Subject: 10CFR21 Reporting of Defects and Non-Compliance -
Engine Systems, Inc. Report No. 10CFR21-0081, rev.1

Refurbished Woodward EGB governor/actuators

10CFR21 REPORTING OF DEFECTS AND NON-COMPLIANCE

COMPONENT: Refurbished Woodward EGB governor/actuators

EXHIBIT 1

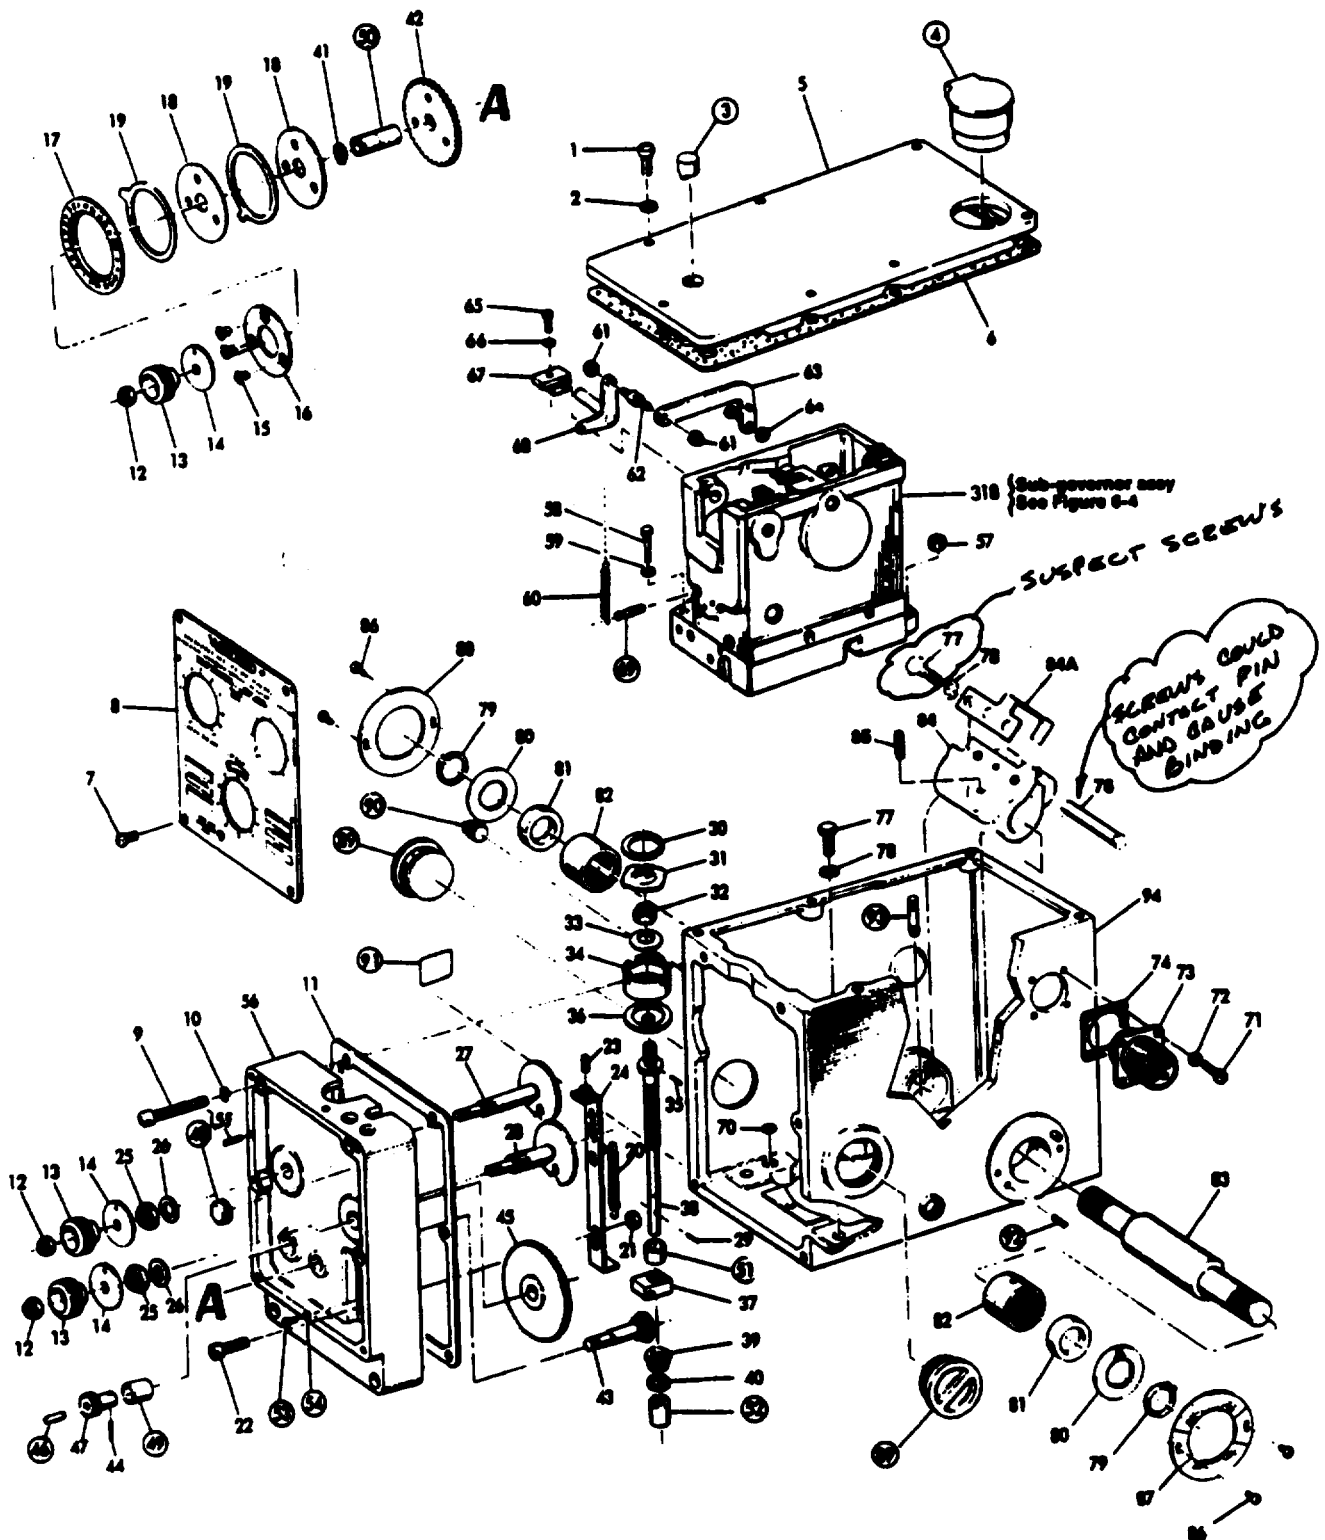
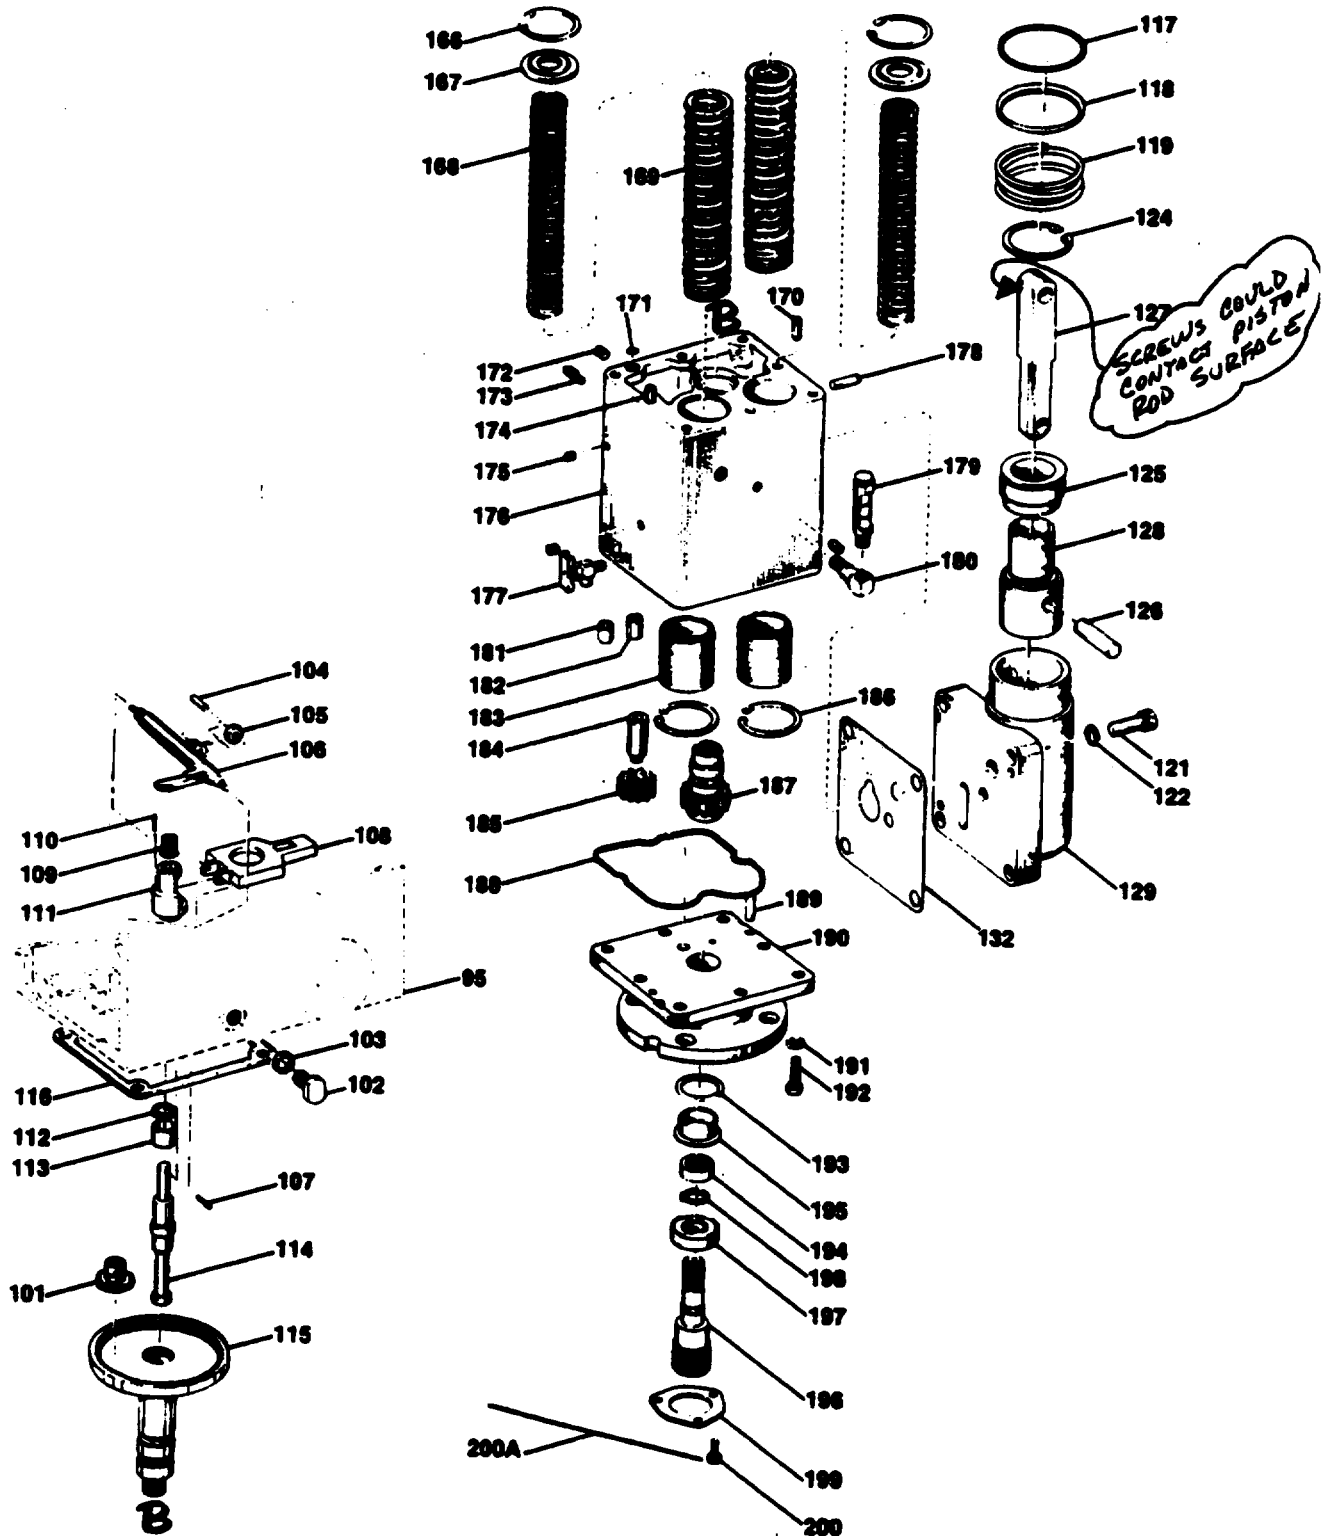
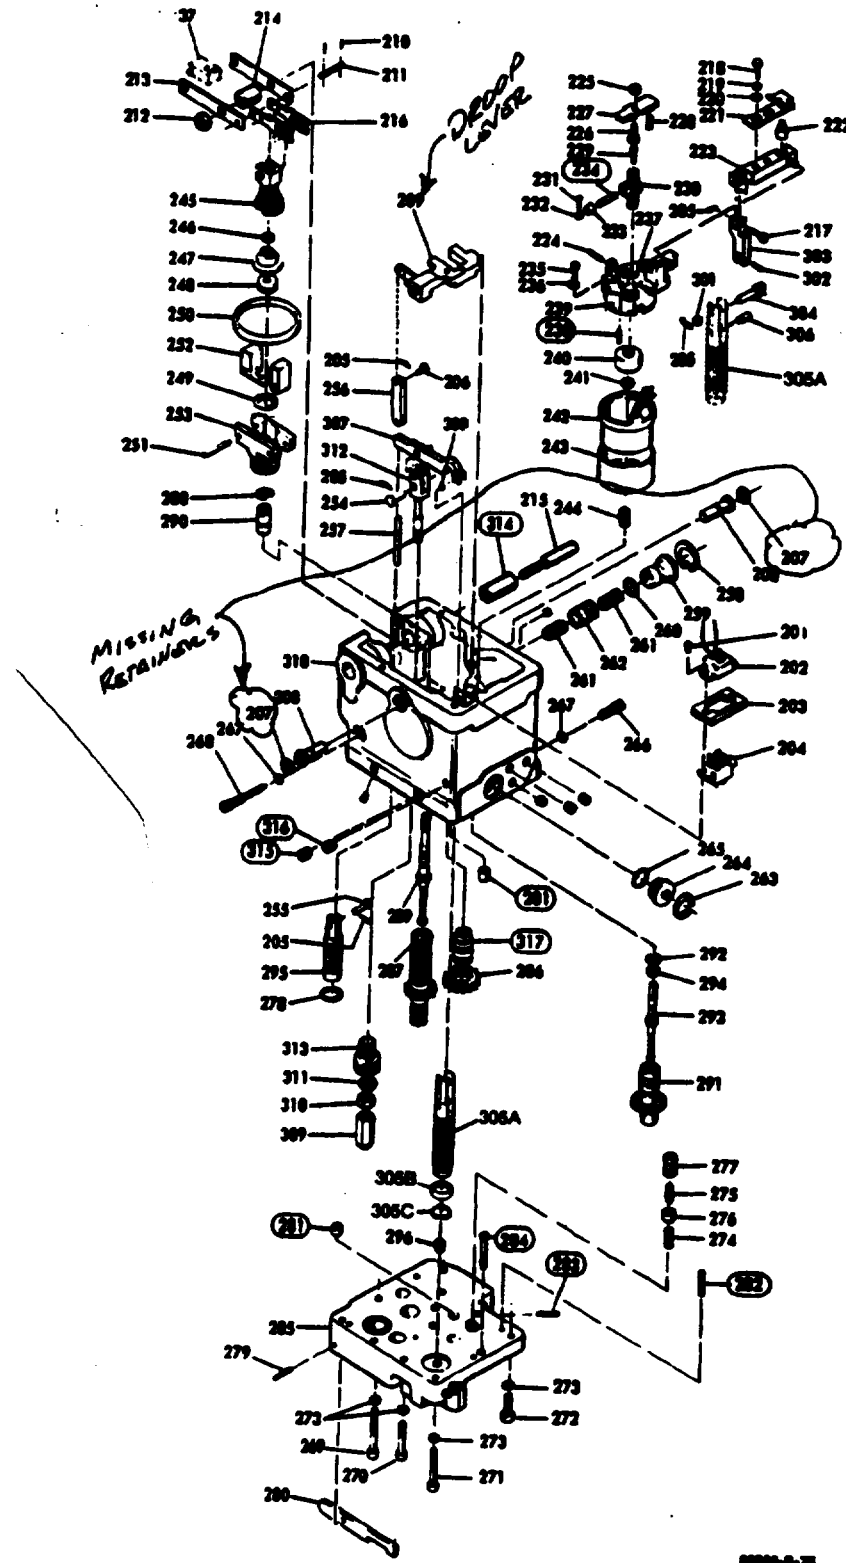
Engine Systems Inc. (ESI) has received notification about a potential problem with some refurbished Woodward EGB governor actuators. One problem was recently reported by V.C. Summer Nuclear Station, via Power Reactor Event Number 37788. Apparently, a governor experienced binding of the terminal shaft due to incorrectly applied clamping screws. ESI was not notified about this occurrence until after the Event Report was issue; therefore, ESI was not able to verify/evaluate the actual components involved. Another problem was also reported by J.A. Fitzpatrick Nuclear Plant with this governor. Operability problems were observed and an investigation revealed that the droop lever pivot pin retaining rings were omitted during reassembly of the governor. Due to the missing retaining rings, the pins eventually backed out, releasing the droop lever. This caused the mechanical speed setting to drop and interfere with electric governor operation (limited load carrying capability). A parts breakdown for the EGB is provided in Exhibit 1 with the above parts annotated.

ESI recommends returning the suspect governors to ESI for a completed tear-down inspection. ESI will reassemble and functionally test to Woodward specifications. NOTE: Even though the V.C Summer governor screw length issue was corrected, we still recommend a complete tear-down to verify all refurbishment activity is within specifications. The Fitzpatrick unit (s/n 2185499) was recently returned to ESI to replace the missing terminal shaft retaining rings. A complete tear-down inspection was performed at that time; no further action on this governor is required. Contact ESI's Customer Service Department for return instructions.
